SEED SLIDE ANTENNA WIRE UPDATE

Instructions to Increase Range of Remote Control

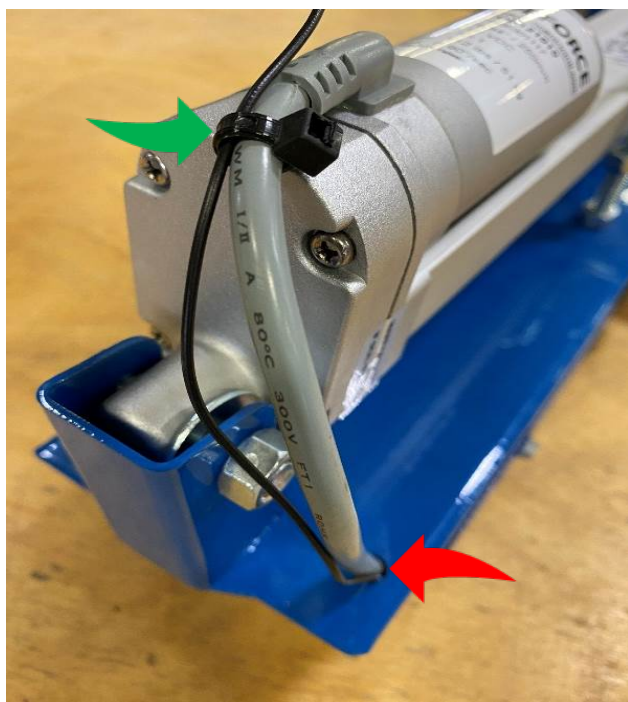
To increase the range of your Seed Slide please take off bottom cover and find the small black antenna wire that comes out of the VERSA2 or VERSA7 control box (it is about 8" in length). Push wire through hole (shown with red arrow) that the grey actuator wire comes out and zip tie as shown on the photo on the left. (shown with green arrow)

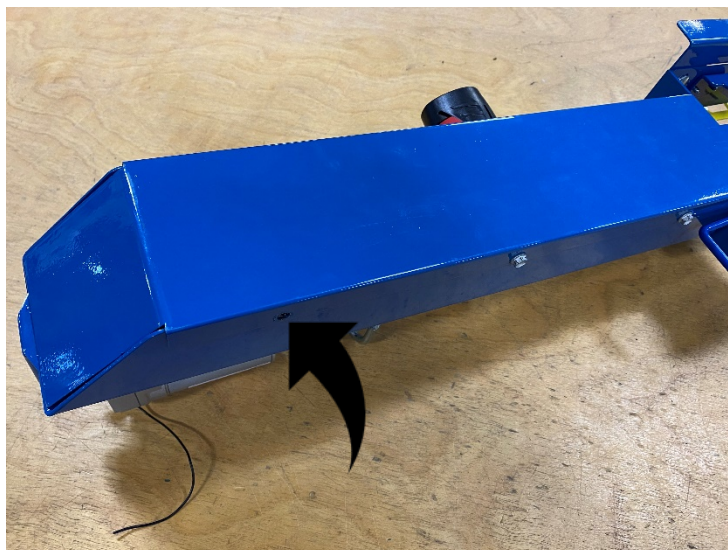
When re-installing bottom cover on a Seed Slide with a VERSA7 Controller (4 buttons on remote) **DO NOT** reinstall the screw shown with the black arrow on the photo to the right. It may damage the VERSA7 control box.
